NUCLEAR REGULATORY COMMISSION

Title: Advisory Committee on Reactor Safeguards
ABWR Subcommittee Meeting

Date: Wednesday, April 24, 2013

FSAR Figure 2.4S.4-13c:
Comparison of BREACH and
FLDWAV Outflow Hydrographs

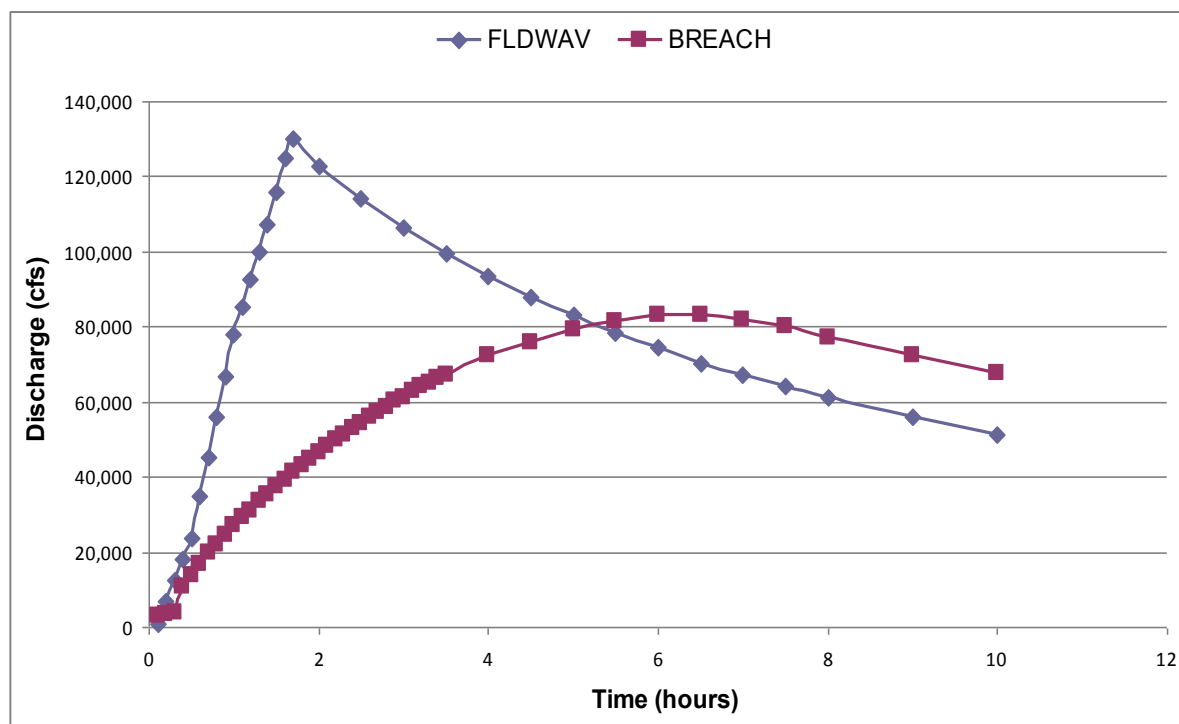
1 And I'm going to show you the results of
2 other aspects of that here in a second. So here
3 again, here is the blue and the red are from the
4 previous slides, is what we've presented before.
5 You see the maximum peak at 417, you see the breach
6 results.

7 But we've added another aspect of the
8 Froehlich equations. If you put information into
9 FLDWAV regarding the breach growth rate and time and
10 width, you'll get the green curve. And so what this
11 shows, we think, is some idea of the conservatism
12 that we have in our analysis right now.

23 MR. HEAD: So if you'll back up just a
24 couple of slides. The 417 and the 398 and the 485,
25 I think answer or that's what we believed was the

➤ Non-concurrence Issues:

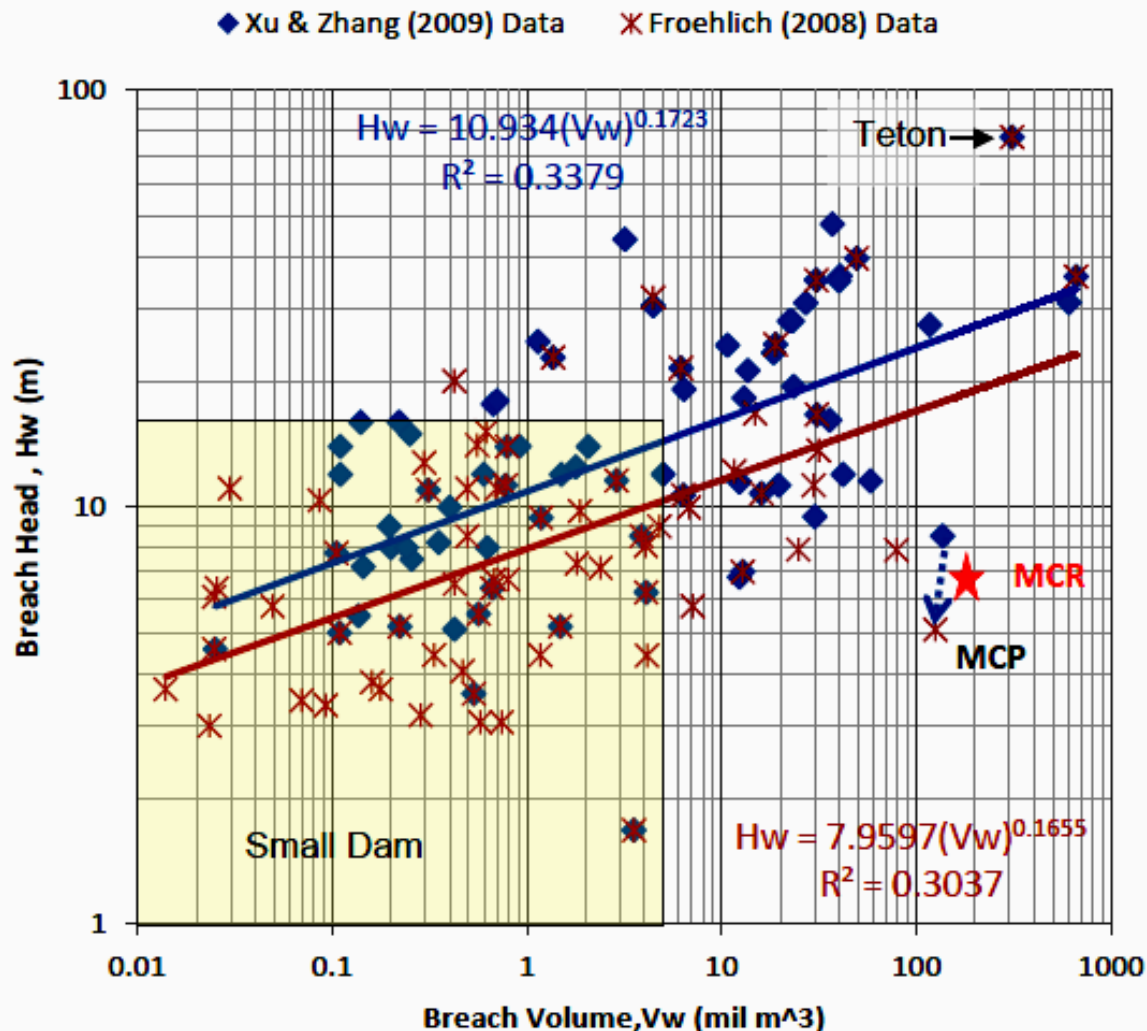
- STP's breach width estimate is not conservative compared to other similar cases:

- ✓ 2000 ft for STP Units 1&2
- ✓ 2034 ft for Victoria ESP
- ✓ 4757 ft for STP FSAR v. 0&1
- ✓ 600 ft on the Martin Cooling Pond breach.

- Other government guides (USBR, USACE, etc.) recommend to '**use all equations, then make an engineering judgment.**' However, STP did not use the MLM breach width equation as well as many breach peak flow equations, resulting in non-conservative parameter estimates (see my re-analysis).

The Staff Used an Unrealistically Small Tailwater Section

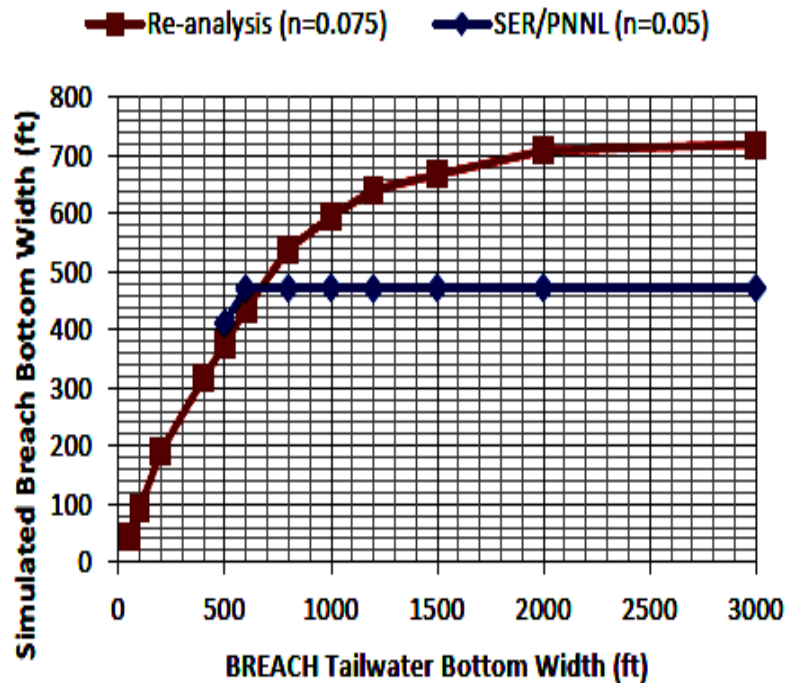
- The staff used an **unrealistically small** tailwater section (width of 600 ft) compared to the anticipated breach width (The same is true in FSAR Table 2.4.4-6b). Then the staff concluded that tailwater section is not critical in breach and that a small tailwater section is realistic.

- I disagree. The MCR breach tailwater zone is wide (>1 mile) overland plain with mild upslope to the North (4 ft to 1 mi), so that the tailwater spreads quickly and widely to the lateral directions - **A wide tailwater section is realistic.**
- My re-analysis shows that small tailwater section produces high tailwater level at the beginning of breach, resulting in reducing breach head and resulting breach width significantly. My sensitivity analysis also shows that tailwater section is very critical in breach.

BREACH: Tailwater Section Width vs. Breach Width

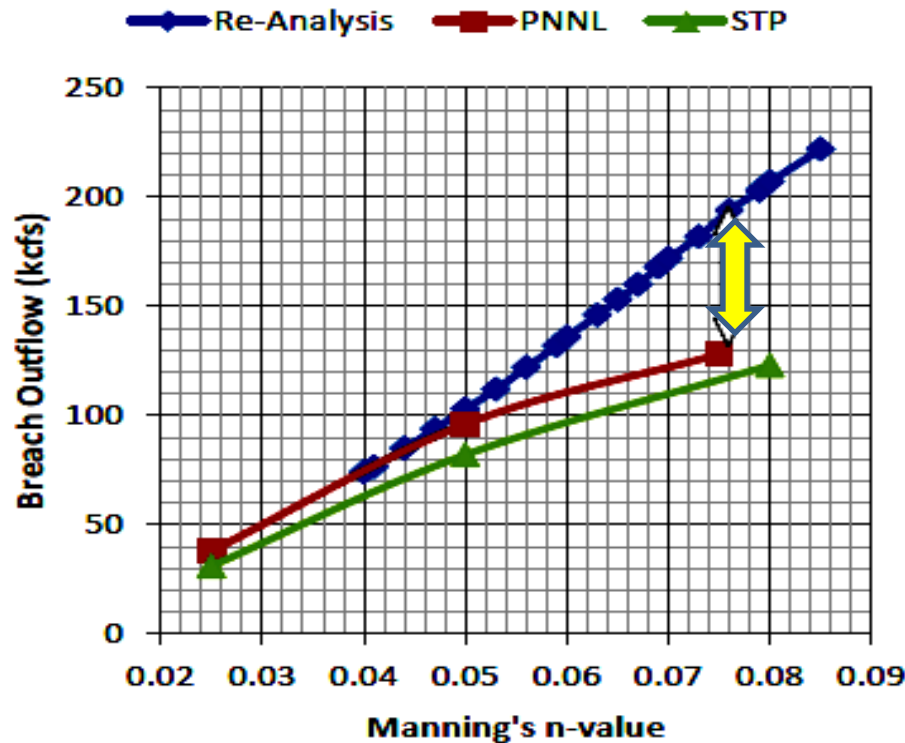
- The staff/PNNL selected $n=0.075$. However, they performed a tailwater section sensitivity analysis with $n=0.05$, then concluded that the tailwater section is not a limiting factor. (SER p. 51) – **This conclusion is incorrect as my re-analysis shows that tailwater section is very sensitive in breach.**
- The staff obtained peak flow of 130 kcfs using BREACH with $n=0.075$ and a small tailwater section, then concluded that STP's breach estimate is acceptable – **The model is flawed.**
- In my re-analysis, I used a width of 3000 ft, but a tailwater width greater than 2000 ft is acceptable (see Ahn, 2012a).

Sensitivity of Two Breach Parameters (n-value and Tailwater Section)

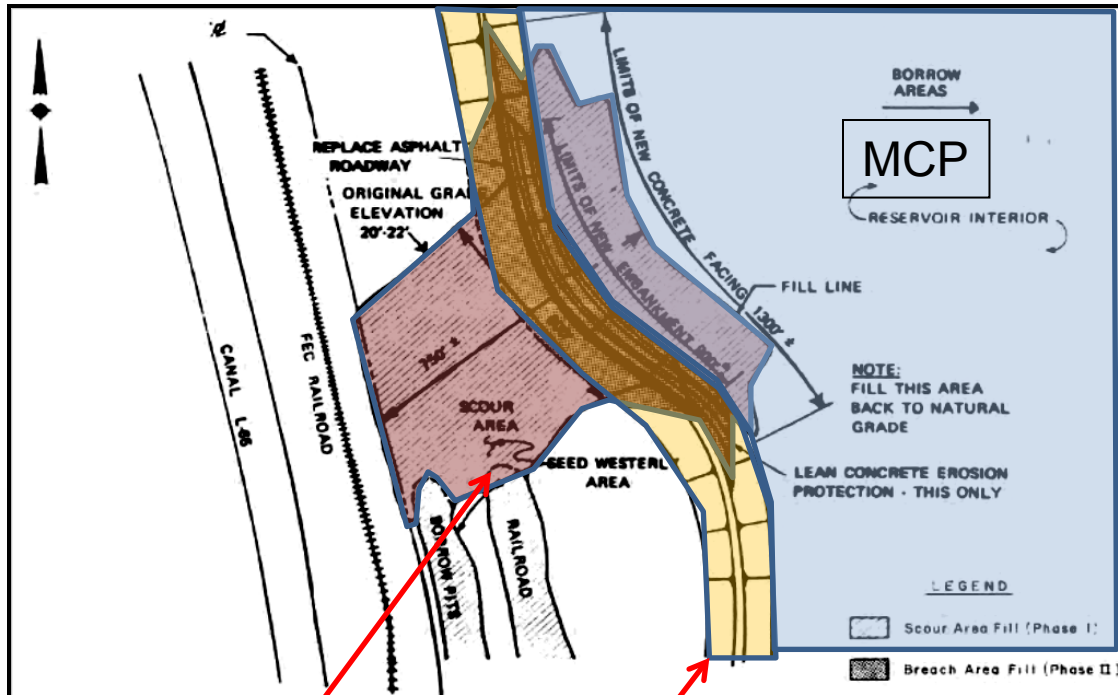
- It is clear from the figure that the staff underestimated breach outflows by using a small tailwater section.

1.4 Scour Hole Issues

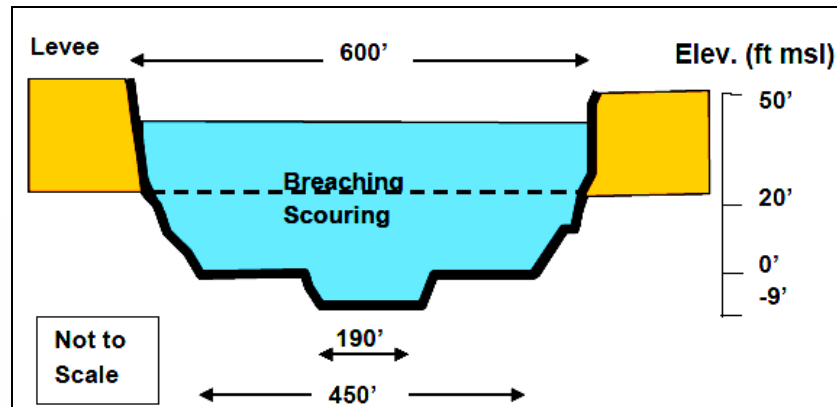
- Levee Breach
width: 600 ft
- Scour Hole
 - Piping started through foundation **sand layers**.
 - Width: 450 ft
 - Length: 700 ft
 - Max. depth: **29 ft**
(~16 ft on average)

#3 Maximum Groundwater Level

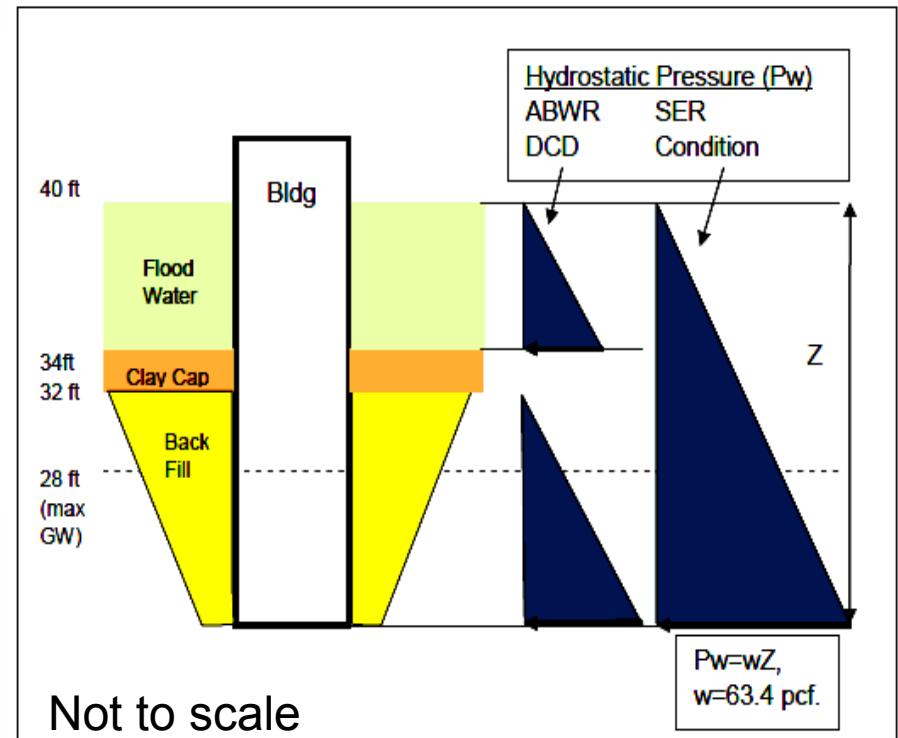
Issue: The departure of the maximum groundwater level (ABWR DCD Tier 1 Site Parameters) is not addressed in subsequent structural analyses.
